4-27-12 5-2-12		5-29-12		Earth Sheltered Technology, Inc. Po Box 5142 Mankato, Minnesota 56001	
				FOOTING PLAN

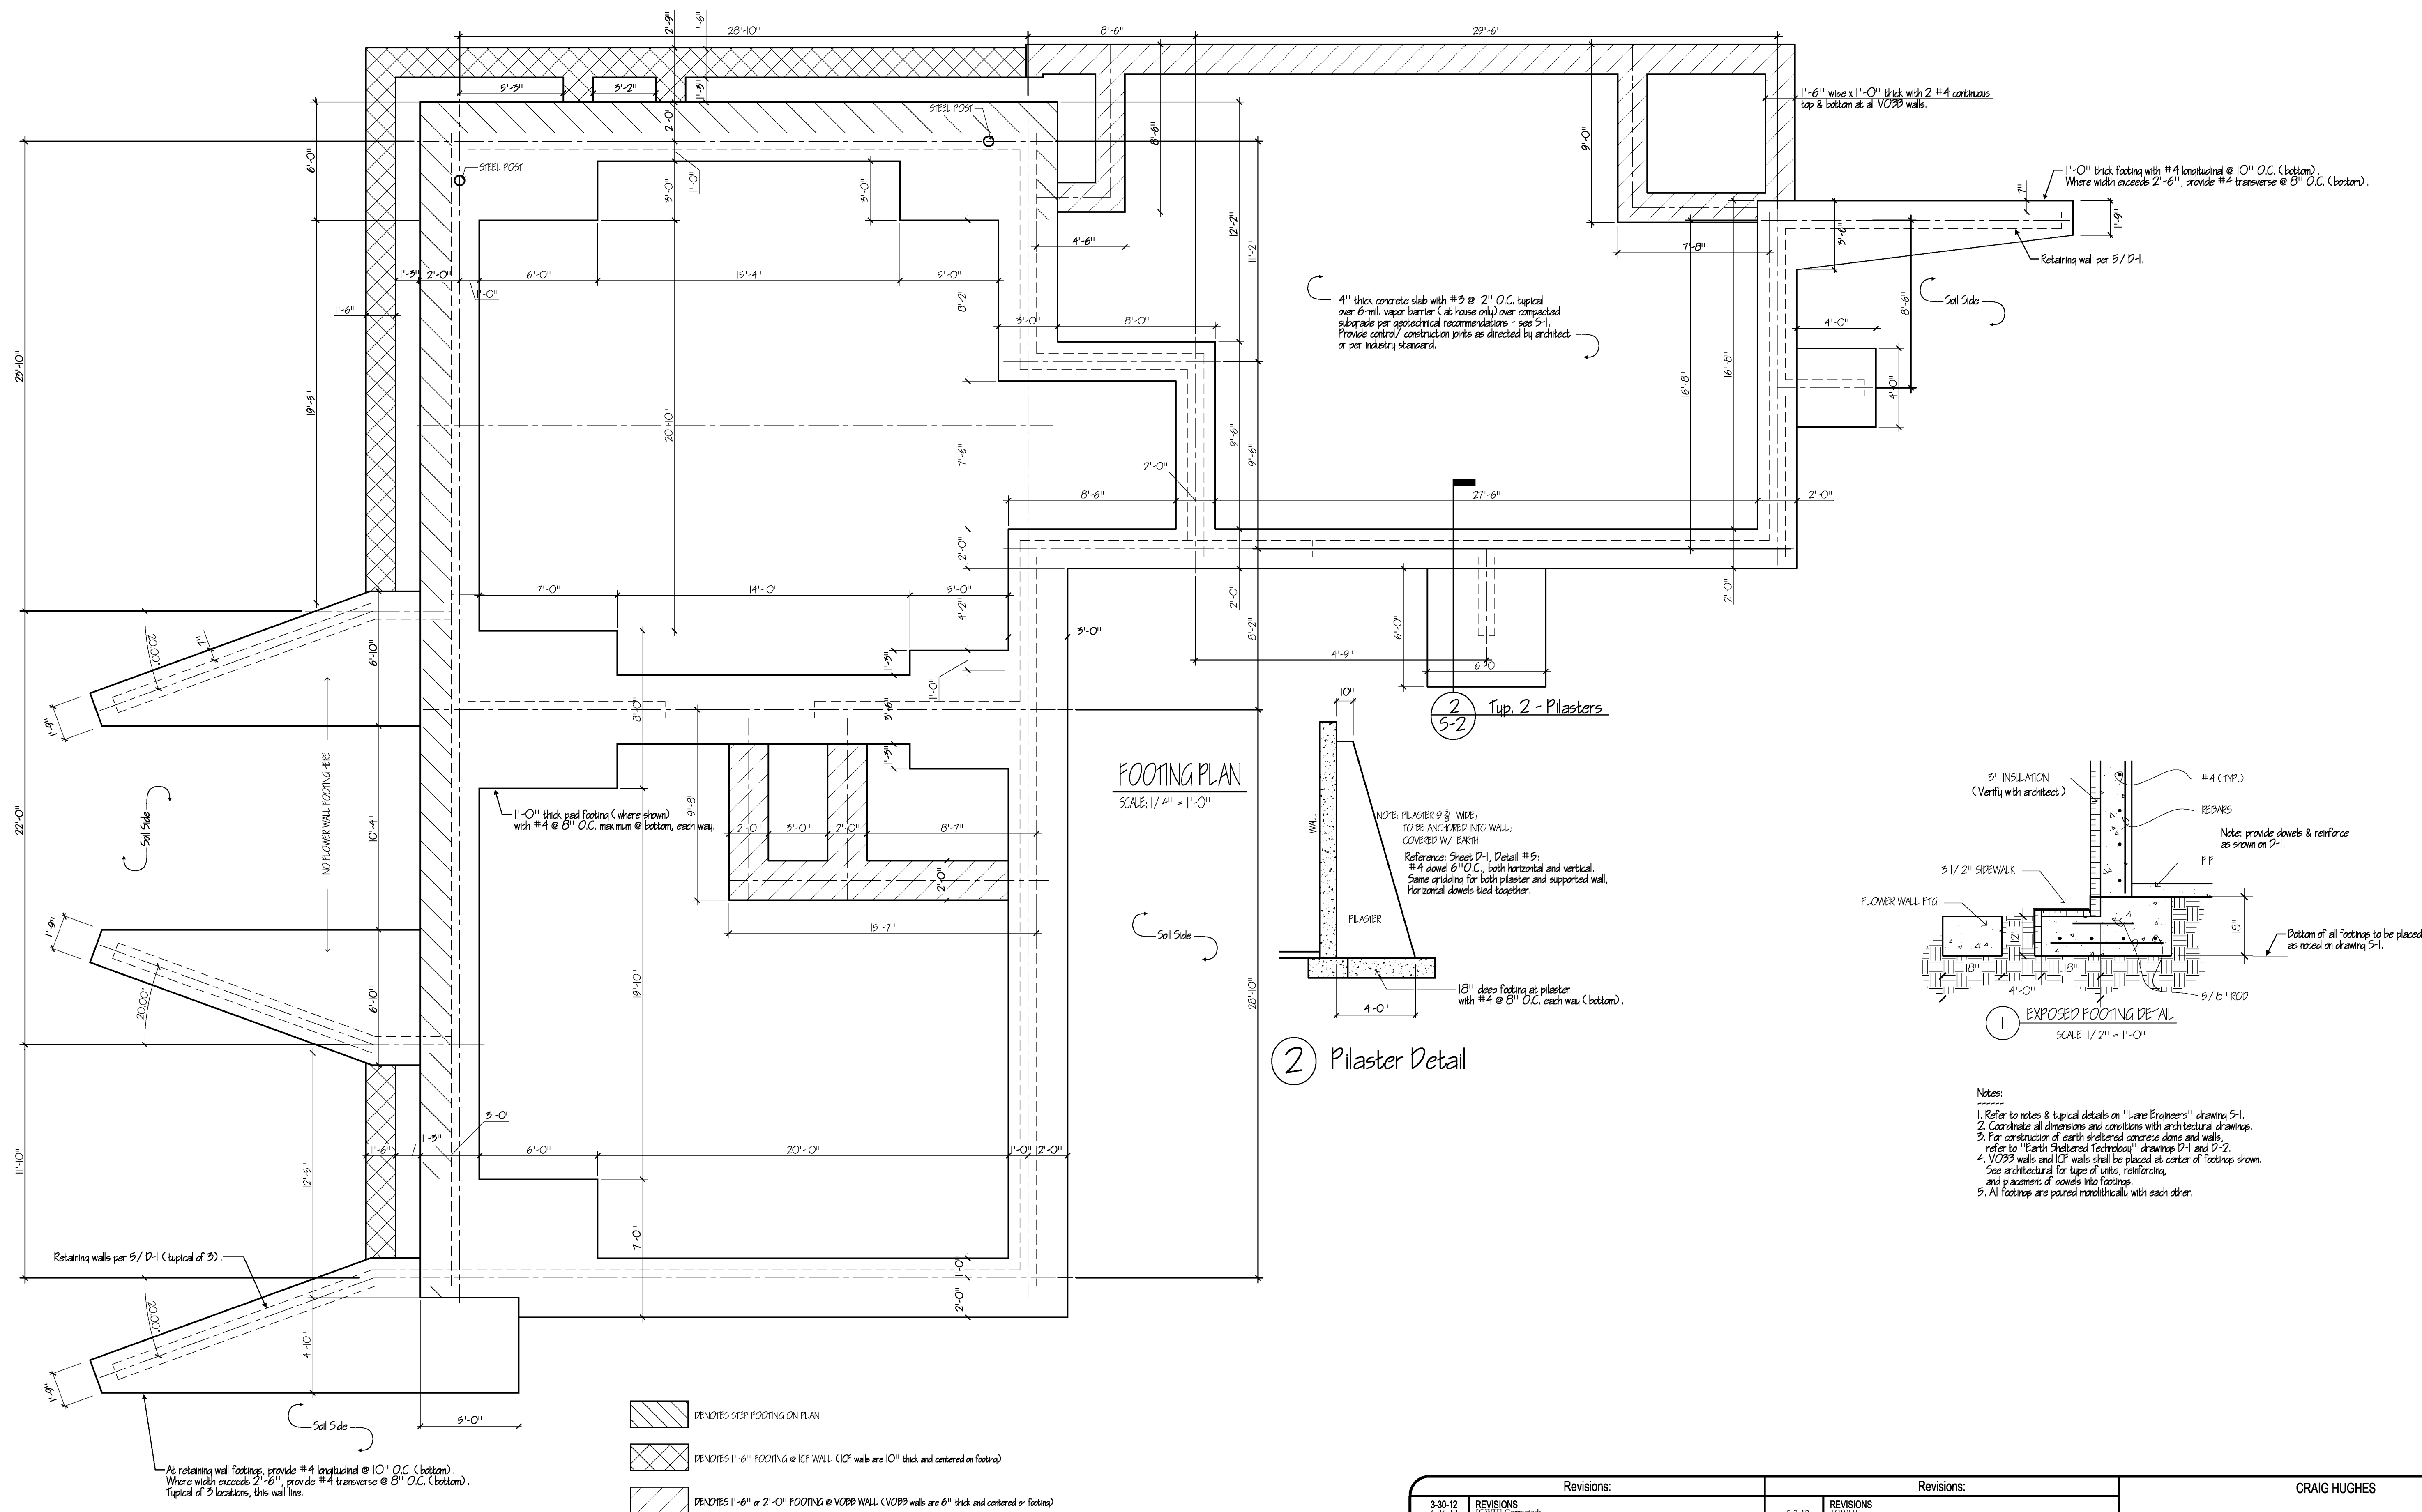
Revisions:		Revisions:		CRAIG HUGHES	
3-30-12 4-22-12	REVISIONS [CWH] Corrected: (1) Bedroom #2 Retaining wall footings (2,3) Interior garage VOB wall footings (4a,4b) Exterior VOB wall footings (5a,5b) Exterior ICF pony wall footings (6) South steel post position [CWH] Corrected: (7) Took out jog in ICF/VOBB wall footing juncture, inserted airlock footings. (8) Put in different type of hatching for VOB wall footings and legend. (9) Changed common wall footing to 3'-6" per Dave's notes. (10) Put in ICF wall thickness, monolith pour and pilaster steel notes. (11) Put in buried wall steel post details and detail callouts.	5-7-12 5-14-12	REVISIONS [CWH] (12) Corrected step footing per Jeff: 2'-0" outside (not 1'-11"). (13) Modified north running wall footing per Dave (weirder). (14) Modified modules back and side walls (buried) footing per Dave (to match the front). (15) Indicated single pour for garage VOB wall footings per Dave. (16) Entered pilaster detail information and citation per Dave. (17) Corrected dangling measurement line/dimension identified by Dave. (18) Added/changed/removed various dimensions and notations per Dave. (19) Added airlock dimensions. [CWH] (20) Corrected south large dimensions.	Date: 4-22-11 Scale: See Plan	Drawn By: ALK
